# Sheraton Hotel & Event Center

## Detailed Information for Exterior Enhancements Price Breakouts

These exterior enhancements were included in the current scope at the request of the City of McKinney, and are above and beyond initial requirements. Pricing for each item is needed to substantiate the added costs to the project. Please note that some items could be removed from the program, and thus the pricing would be deducted from the submitted program and price. The following pages outline each of these enhancements, and correspond to a line item on the bid tab for the breakout pricing.

# A. Alignment of North Entry Face and Change Brick to Stone

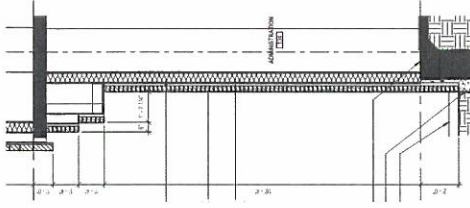
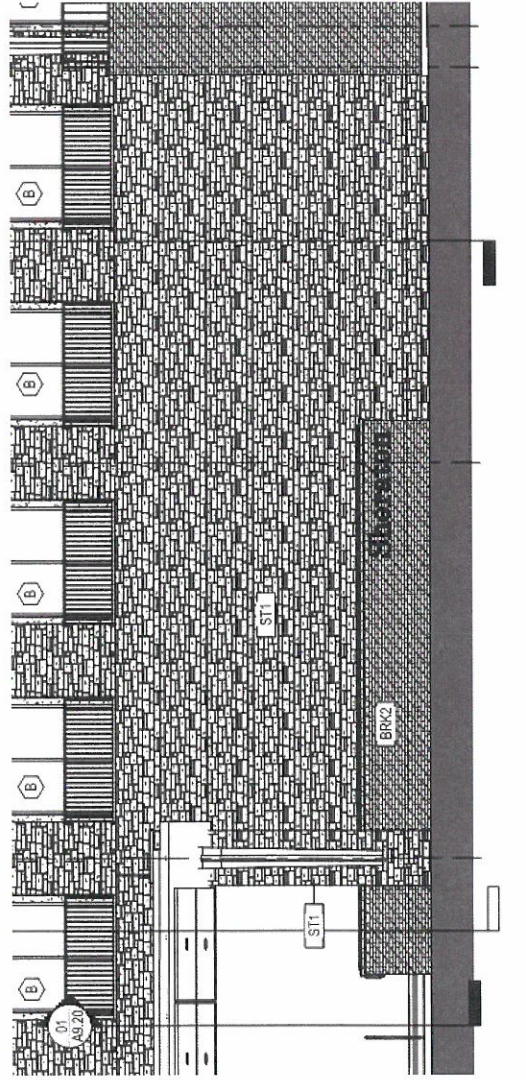
- Change Brick to Stone Veneer
- Include area over canopy.
- Delete plaster soffit from 'old' (see section)
- Move windows to Admin (net zero delta)
- Add grade beam and SOG per new section.
- Add floorspace inside.

## B. Add Stone / Remove Plaster at Level 4 Windows

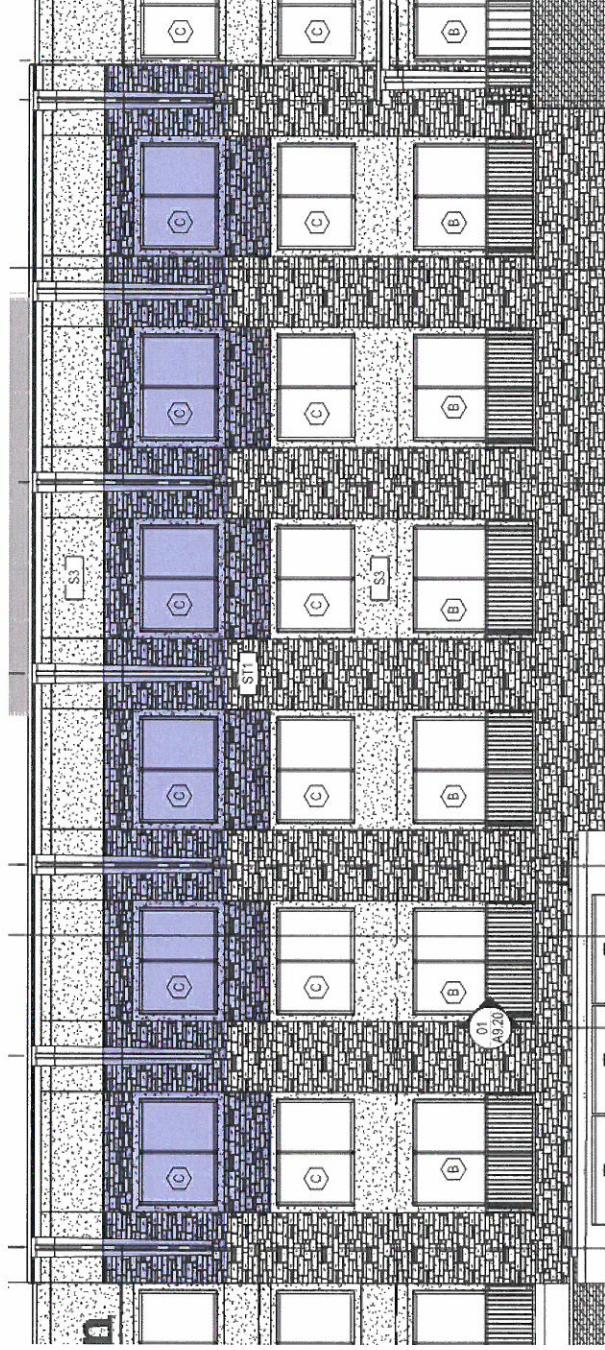
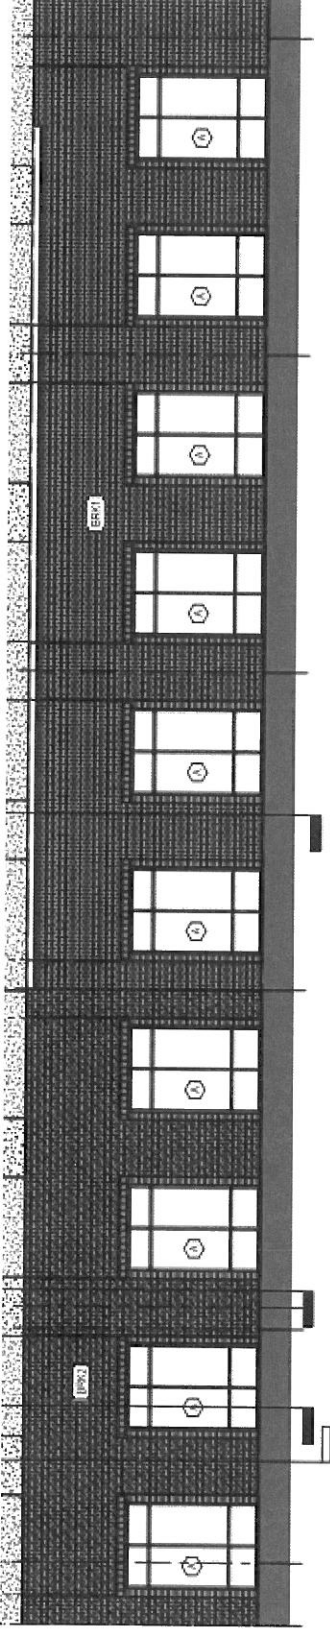
Occurs at both the North (main entry) elevation and the South Courtyard elevation, shown below. Area for breakout is shaded in blue, below.

- Add the stone veneer and delete the plaster finish at the shaded areas.
- Include any misc steel for headers, including embeds. Steel to be painted.
- Flashing and waterproofing details.

## C. Group Level One Guestroom Windows Together

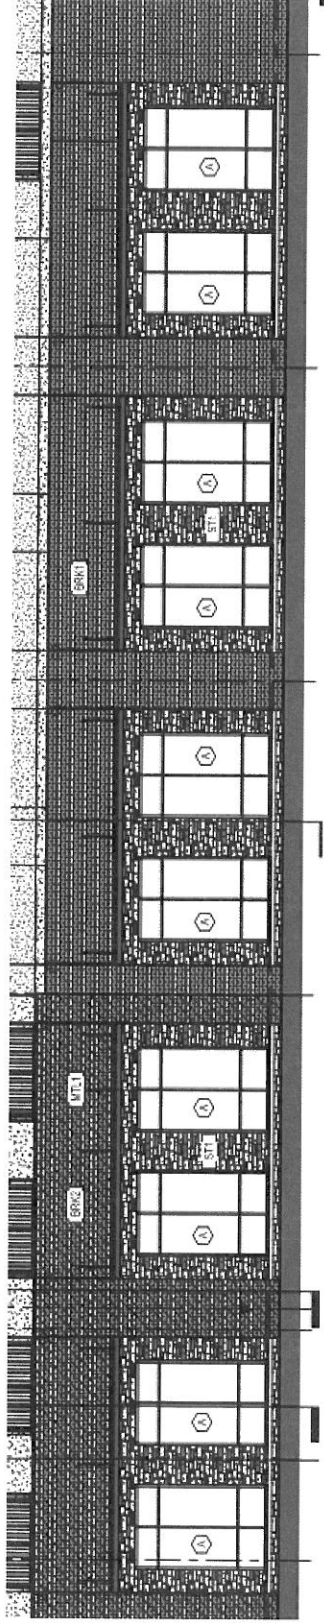
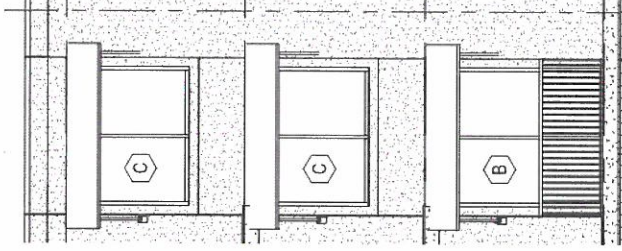
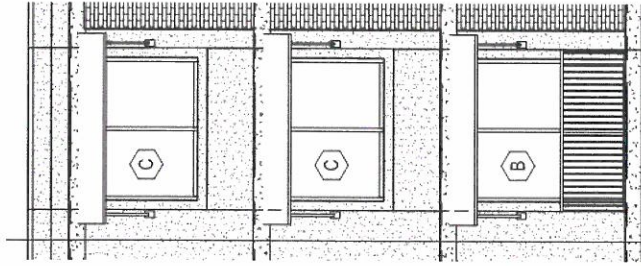
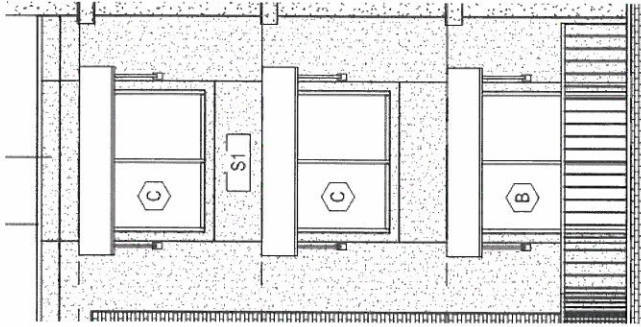
The windows stay the same size in this item, but grouped as pairs by moving closer together.

Brick is changed to stone veneer at the window pairs. Brick detailing remains, but is now at each grouping, not each individual window.

Add misc steel for headers, including embeds. Steel to be painted.

Flashing and waterproofing details.

**NOTE:** The above represents the west elevation only (10 windows). Same item is repeated on the courtyard side (8 windows) and north elevation (4 windows) for a total of 22 windows, or 11 groupings.

## D. Add Awnings

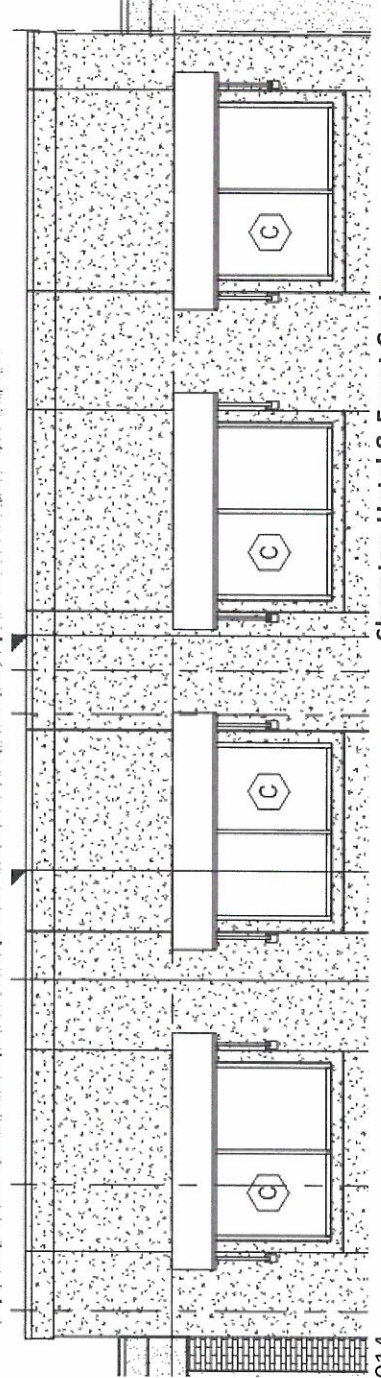
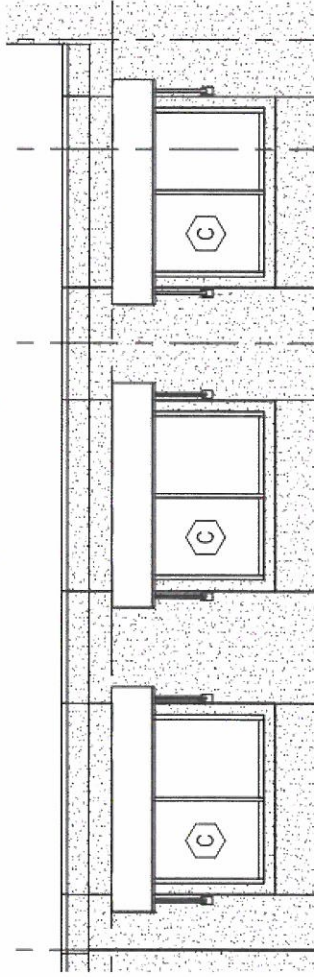
Add awnings over upper level windows on various elevations.  
Include framing reinforcements and blocking.

### E. Add Shade Canopies at Level 1 Windows (including support)

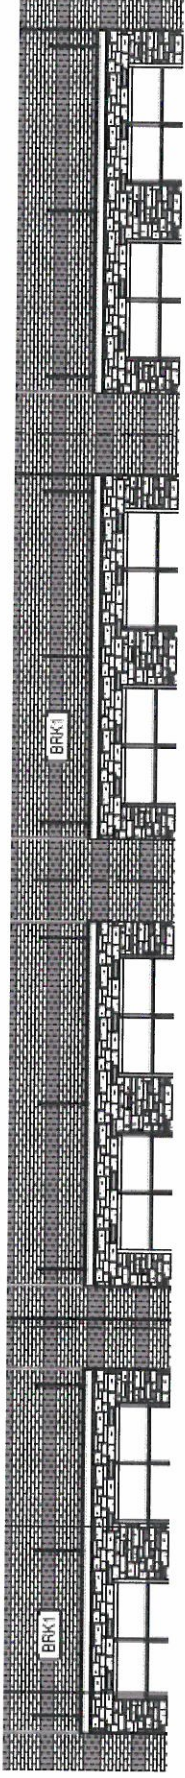
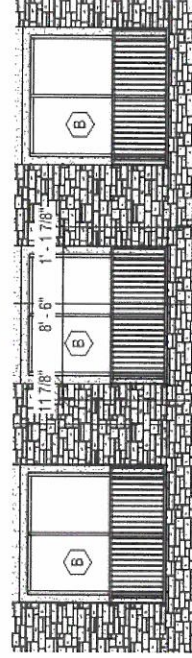
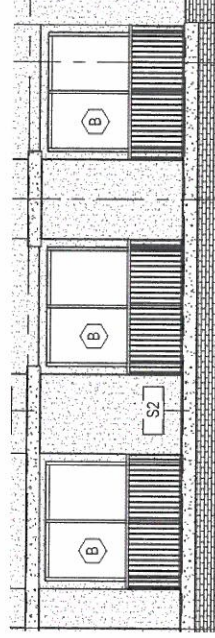
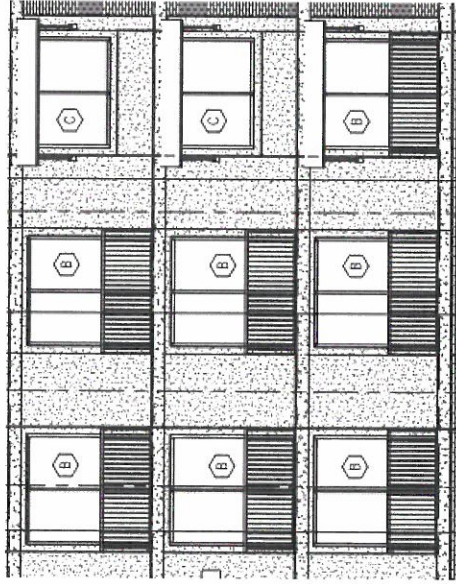
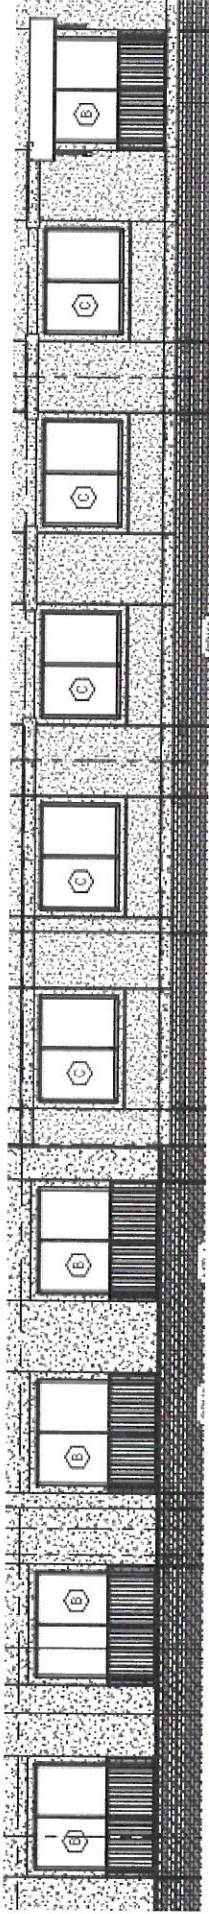
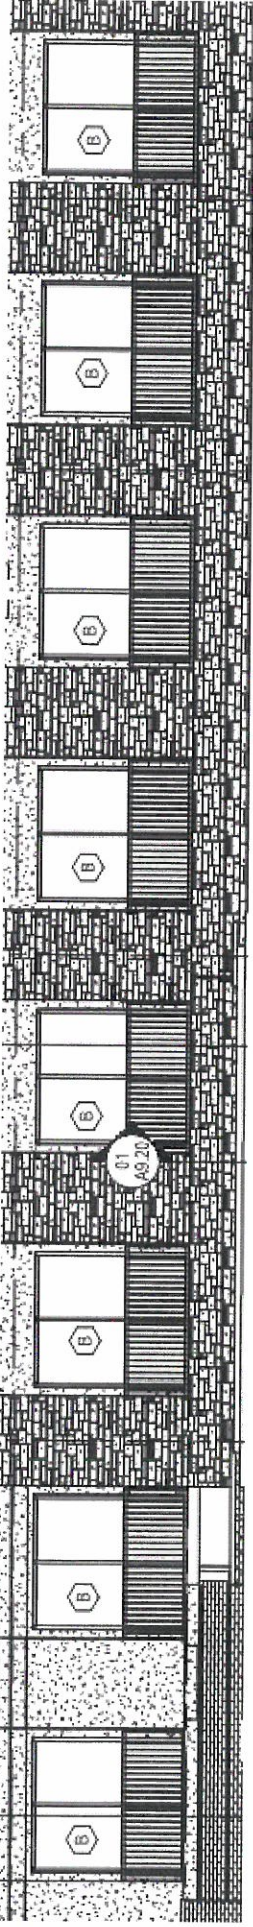
Add canopies over level 1 windows on various elevations.

Include framing reinforcements and blocking.

Some canopies are larger in courtyard (4) than at typical locations (11).

**F. Add Juliet Balconies & Enlarge Windows**

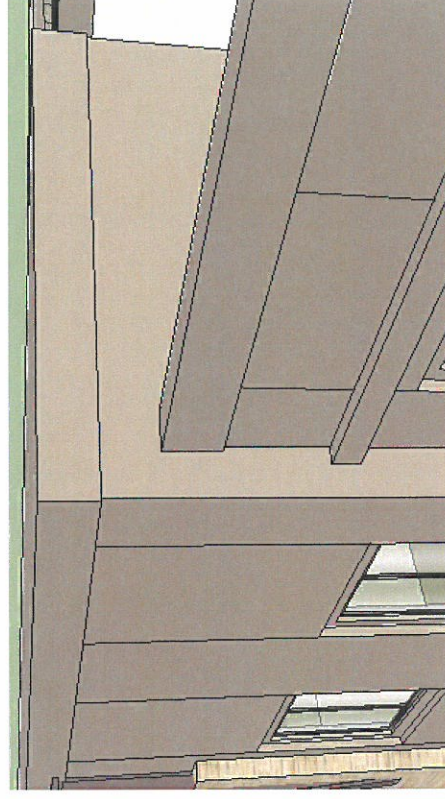
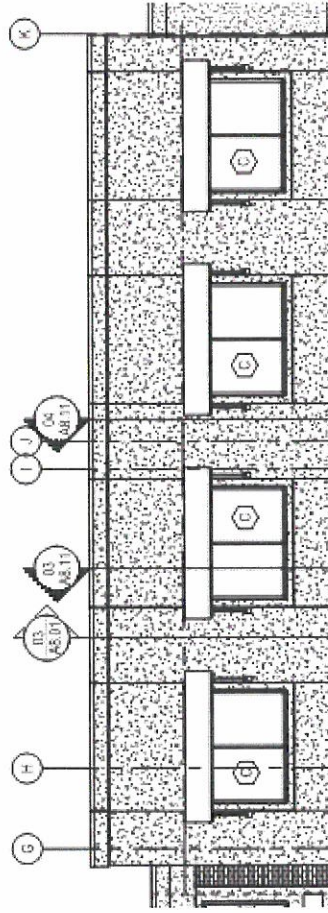
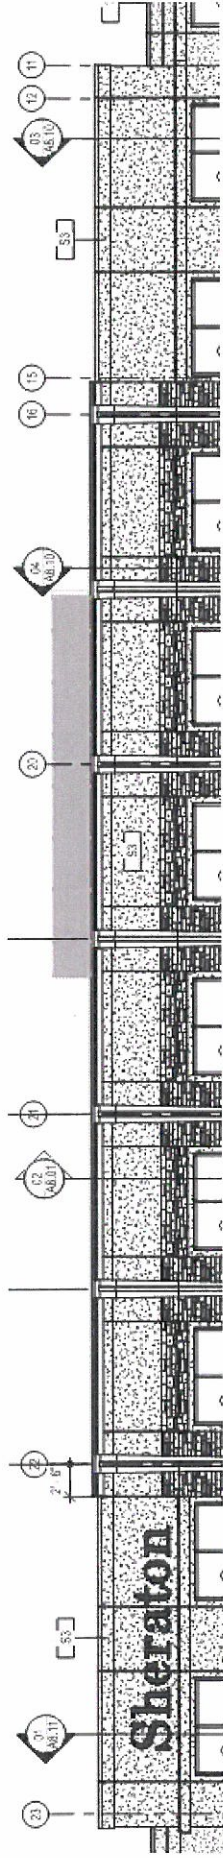
Add ornamental railing at various windows on hotel elevations.

At same locations, enlarge windows (Type B) in lieu of standard window (Type C).

Noted as 26 locations

## G. Raise Parapets

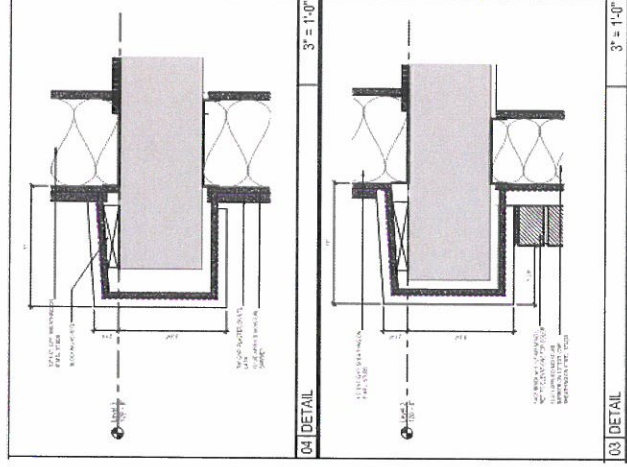
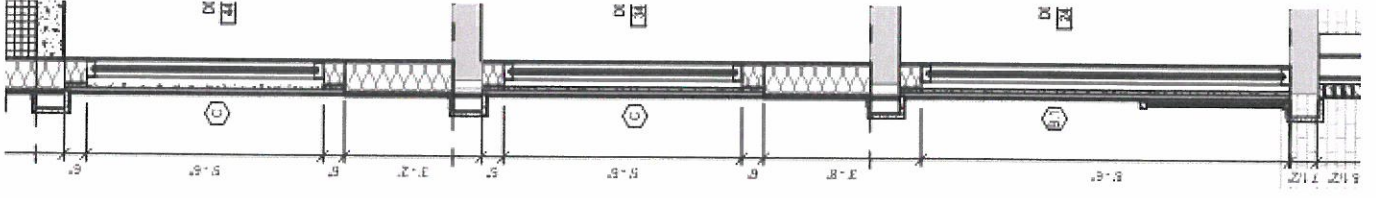
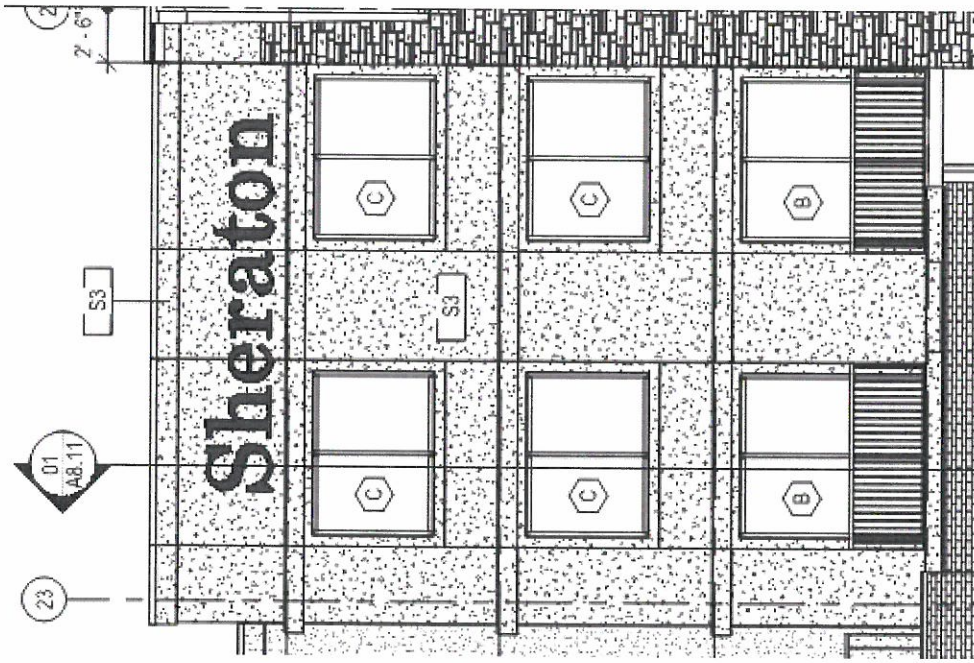
Raise parapets on West and North elevations by 4'-0".

Also included is the 'return' of the parapet walls. Each return wall is 4'-8" in length.

Costs included should be entire wall framing system, support steel, and added roofing on back side.

# I. Change Courtyard Exterior Materials

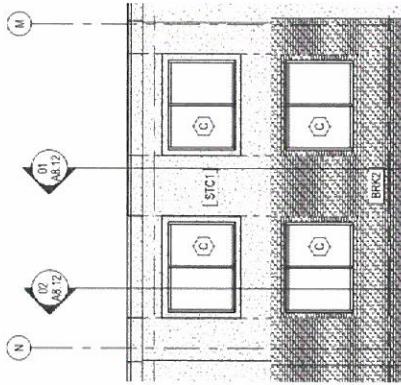
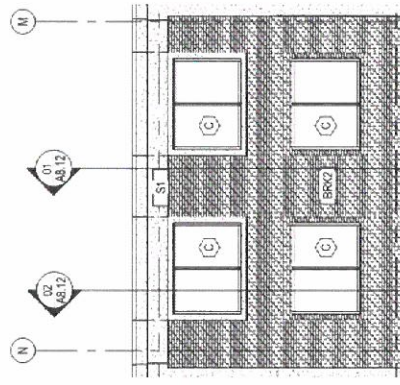
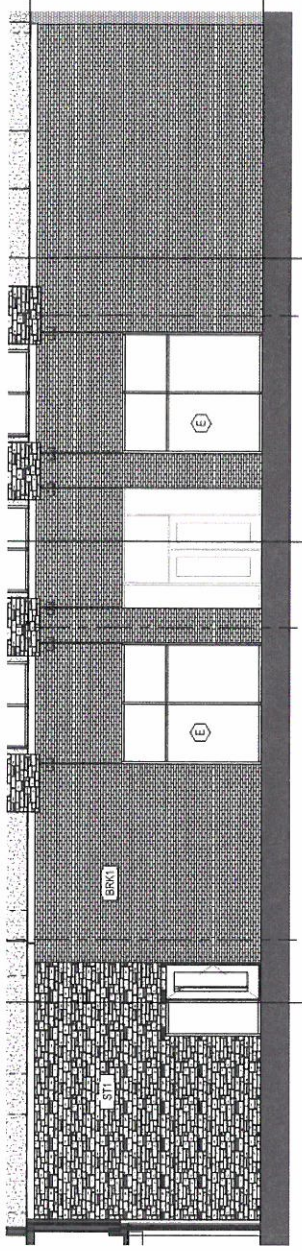
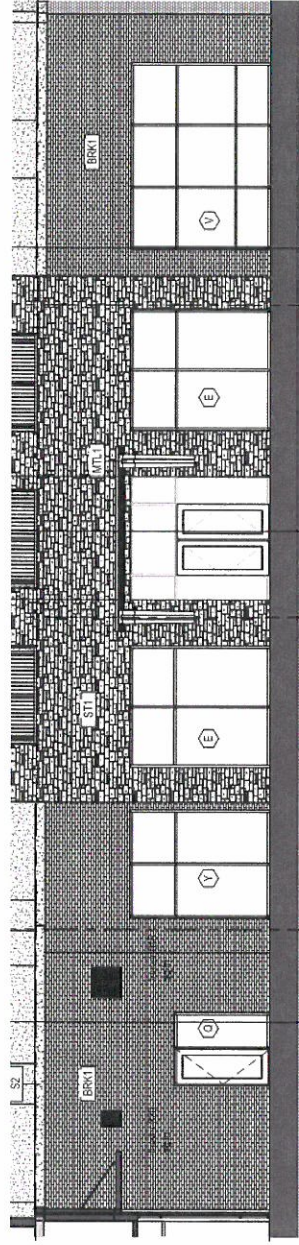
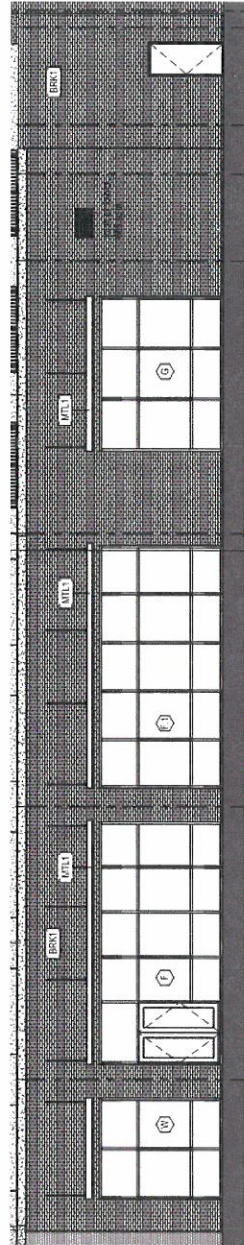
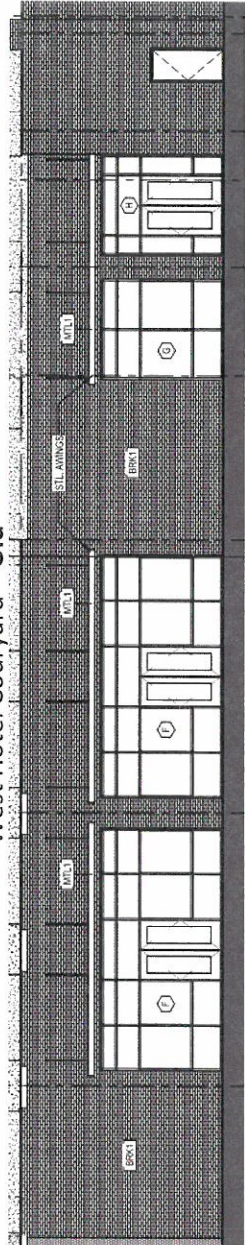
- Revised Brick Areas
- Revised Stone Veneer Areas
- Revised Glass Areas
